SUBMISSION PM & DC BROADHEAD

INVERARY PARK, 40 BROADHEAD LANE, BUNGONIA

OBJECTION TO ARDMORE PARK QUARRY MODIFICATION (MP 07-0155 Mod 3)

This is a graph of our Spring compiled with all our data.

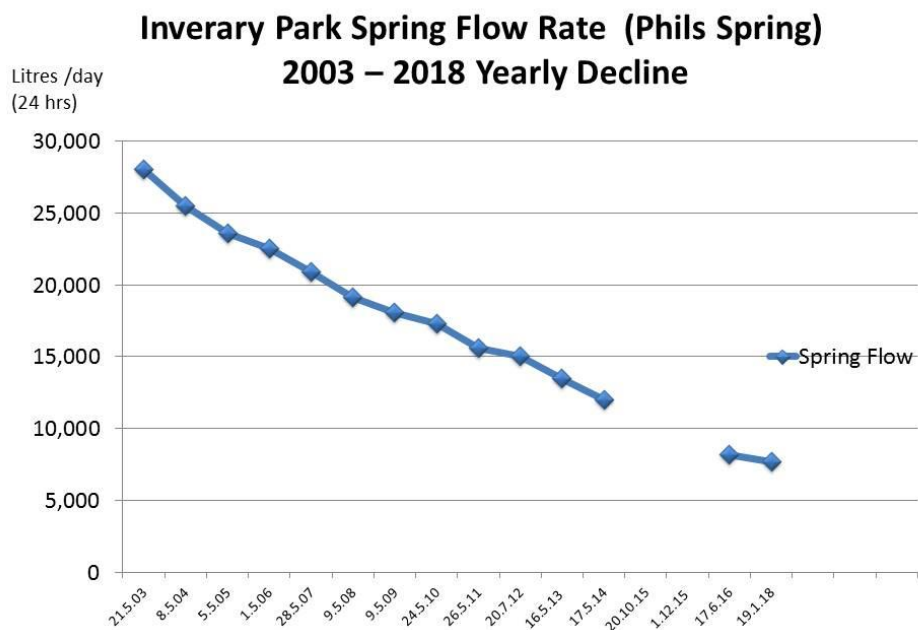
Since 2003 when Multiquip (CEAL) were proposing a Chicken Farm, we have been recording Spring Flow Rates for (Phil's spring) Inverary Park. It can be seen very clearly by the following graph below, the steady decline from 28,000 litres a day (21/5/2003) to 7,700 litres a day 5.1.2018. Our minimum requirement for stock alone in summer is 10,000 litres a day. This spring has been flowing since white settlement and used for over 80 years on this property as the main water source. Unfortunately there is no flow data available pre 2003, however we could always pump 27,000 litres a day every day in dry weather without fail to a header tank.

While Larry Cooke describes our spring as fluctuating, this may be on a monthly scale as seen above, it will fluctuate with rainfall & storms. However when you take it on an annual basis as seen below, it is a steady decline. Anyway you look at this it can only be described as Depletion. Depletion in which has never occurred here until the bores were put in on Ardmore Park and they started extracting water. We have all the figures for the years recorded if you need copy.

Figure 6: Locations of Monitoring Bores and Springs

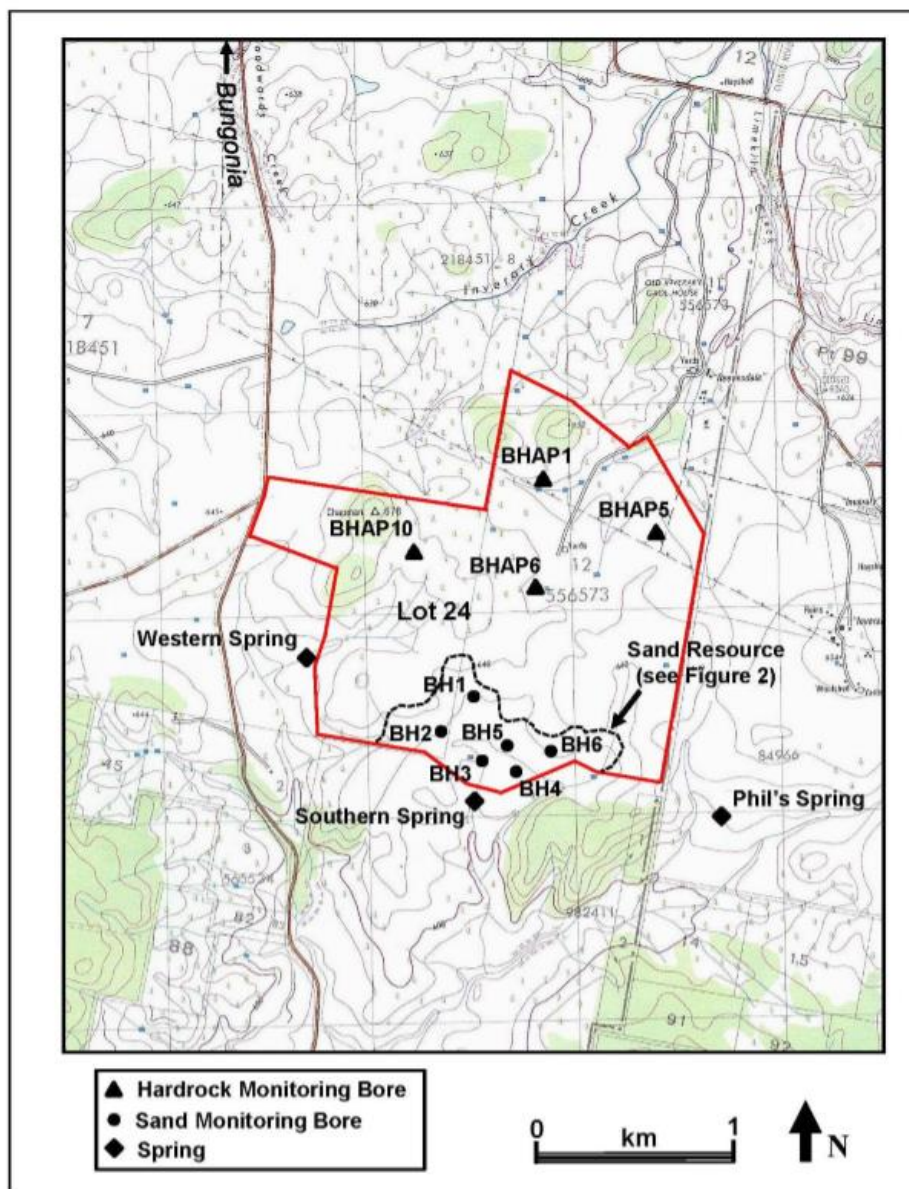
The below picture is taken from the **Proposed Modification 3 - Appendix 10 - Hydrology Assessment - Figure 6 - 9.3 – Aquifer Discharge - A10-21.**

(This picture shows locations of the bores on Ardmore Park and also our Spring (Phils Spring) on Inverary Park.

This is the only current data (11 April 2017) we could find that shows what the most current Standing Water Levels are available to the public for the Ardmore Park Bores.

If you compare this data of the Standing Water Levels with the data on the next page you will start to see that when they tell us that their water levels have not changed, they are not telling the truth.
